Rezoning Transportation Analysis

Petition Number: 2026-001

General Location Identifier: 05326108, 05326109

Date	Description
2-25-26	First Review (IW)

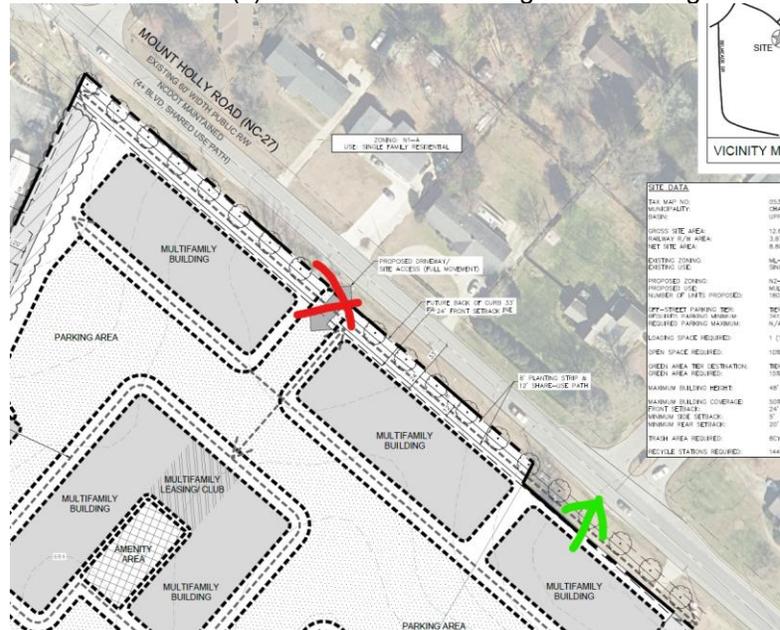
- a. **Mt. Holly Road:** Location of future back of curb and gutter to be constructed 33-feet from centerline.

4+ Boulevard, Shared Use Path from Streets Map

Label and dimension the curb and gutter from the centerline for each road on the site plan.
